# EAGLE GOLD PROJECT

Response to June 2012 YESAB Request for Additional Information  
(YESAB Assessment 2010-0267)

133-77355.12001

July 2012

**Figure R1-1: Eagle Gold Project – Estimated Heap Leach Facility Draindown Flow Rates**

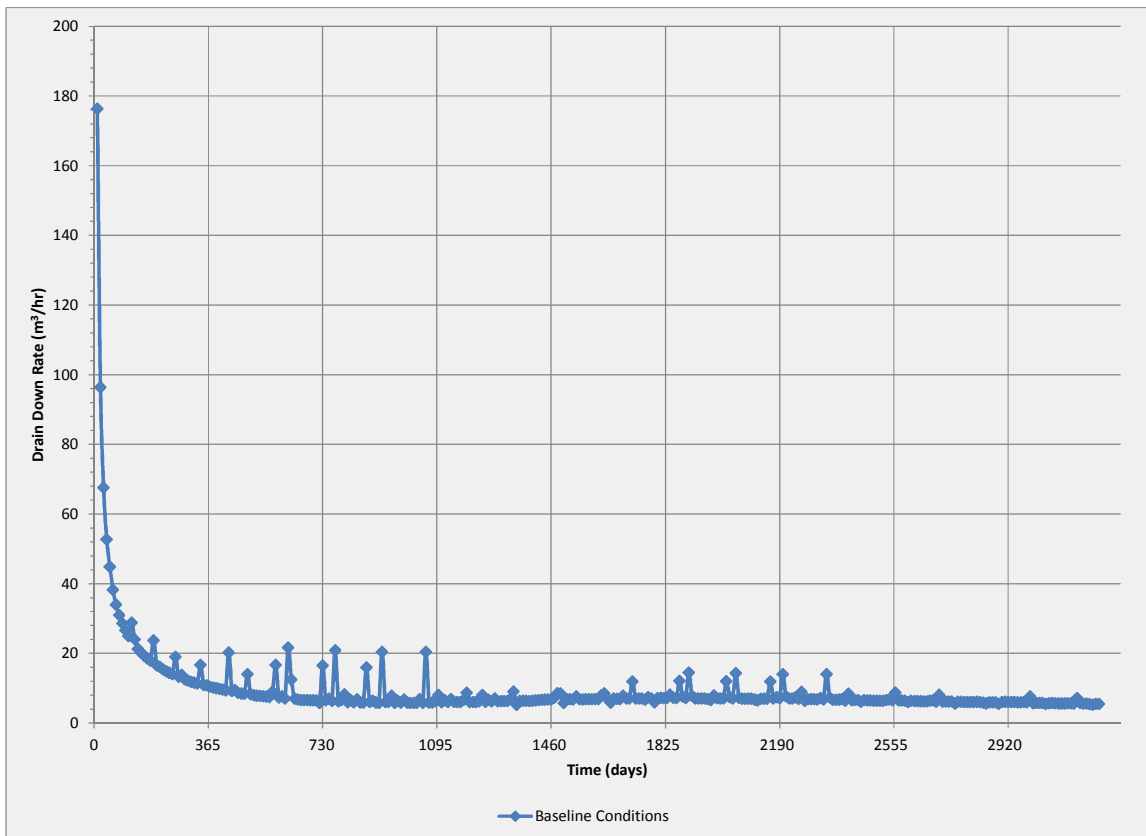
### **R1-C) Estimates of draindown timing and leach solution travel times.**

A simulation of draindown resulted in the draindown flow rate curve shown in Figure R1-1. The baseline model results presented in Figure R1-1 was constructed assuming a free draining heap with only precipitation inputs of water (no water management or recirculation). The precipitation inputs (snowmelt or rainfall events) result in the short duration spikes of increased draindown rates shown in the figure. The draindown rate resulting from the modeling of the current 92 million tonne heap is similar to the previous 66 million tonne scenario modeled. Under both heap configurations, the flow rate of the draindown decreases to 10 cubic meters per hour (m<sup>3</sup>/hr) after a few years. Within ten

years, the flow rate of the draindown is relatively stable at approximately 5 m<sup>3</sup>/hr, which is representative of the steady state long term drainage conditions of the heap.

The flow rates presented in Figure R1-1 are estimated to result in approximately 800,000 m<sup>3</sup> of water being drained in the first 10 years after rinsing. This is less water than was previously estimated to have drained over the same period in the 66 million tonne heap models. However, the previous modeling considered only one zone (over the entire heap) draining uniformly from an initial moisture content of 13.3%, while the model now considers that there would be four zones of the HLF that would be in different phases of rinsing and draindown. The modeling for the initial case (66 million tonne heap), was more conservative in that the estimated drainage volumes would be proportionately larger in the same period of time. The current estimated draindown volume of the 92 million tonne scenario is more realistic and has three quarters of the facility at moisture contents of 5% to 10% (assumes that three-quarters of the facility has been draining for 150 to 450 days), and one-quarter of the heap at the initial rinsing moisture content of 13.3%. The draindown volume over time for the simulated 92 million tonne heap is presented in Figure R1-2.

**Figure R4-1: Ore & Waste Mined by Year**

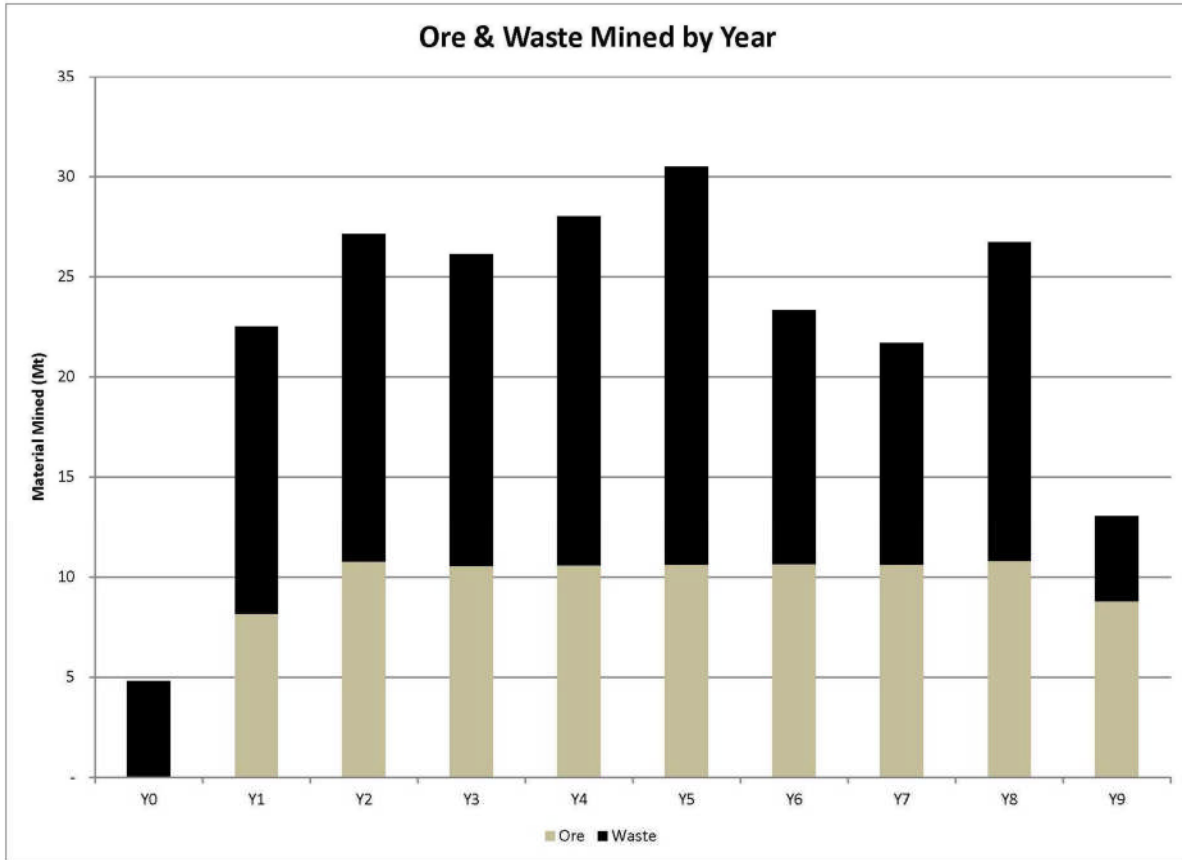
**R4. The volume and destination of each rock unit that will be removed from the pit.**

Figures R4-1 and R4-2 provide the various material types removed from the pit by year and to each destination (waste material to Eagle Pup or Platinum Gulch WRSAs and ore to primary crusher, 100-day stockpile and HLF). The pre-strip material (approx. 5Mt) is included in the Year 0 quantities.

**Figure R6-1 Groundwater Elevation Summary, Ann Gulch Monitoring Well MW10-AG3a**

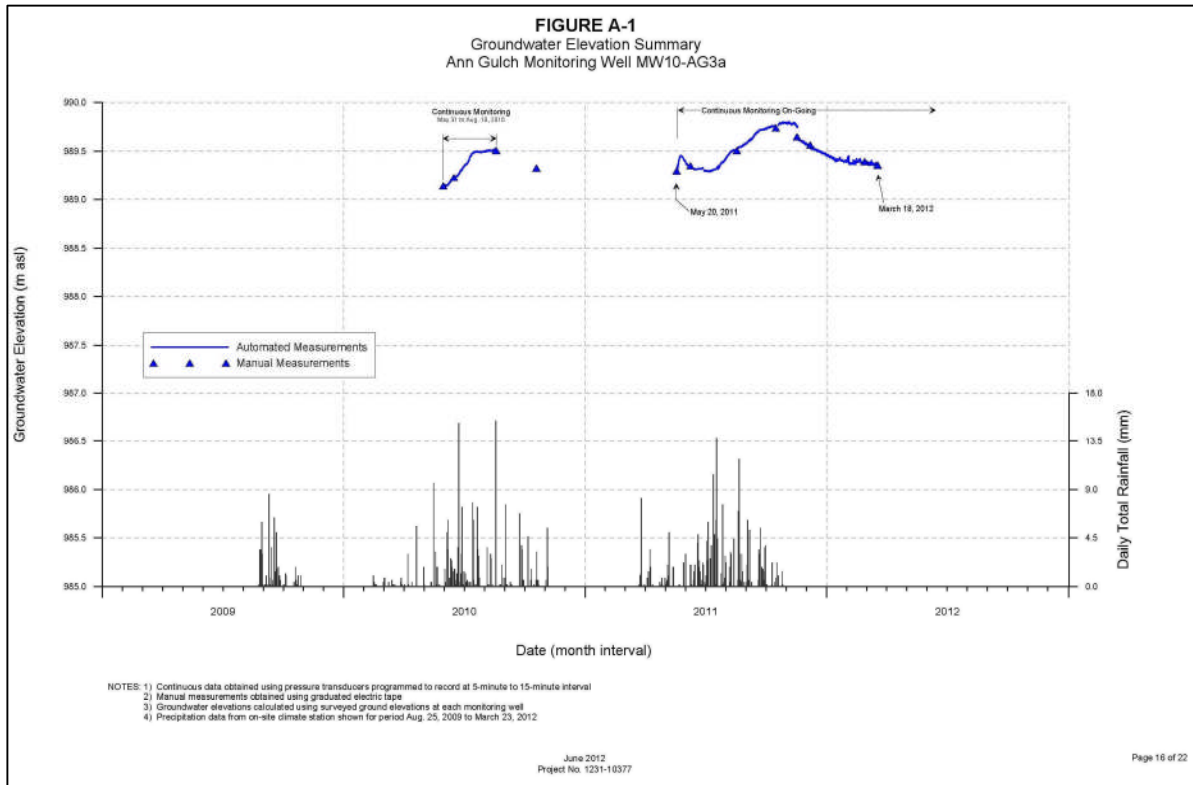
**R6. Provide rationale outlining the suitability of the liner system outlined in the Supplementary Information Report, considering:**

In general, based on continuous and instantaneous groundwater level data collected from wells in the Ann Gulch basin, the seasonal and year to year variation in depth to groundwater has been less than 1 m at any particular location as indicated by Figure R6-1 (Stantec 2012). Figure R6-2 provides a hydrogeological cross section for the Ann Gulch Valley where the HLF will be constructed to illustrate the baseline groundwater conditions and HLF infrastructure. Figure R6-2 is reproduced in this response from Figure 5-2 of the Stantec 2011, Hydrogeology Baseline Report Appendix 15 to Project Proposal. Since the proposed HLF will occupy the entire sub-basin once the HLF is fully constructed, the HLF
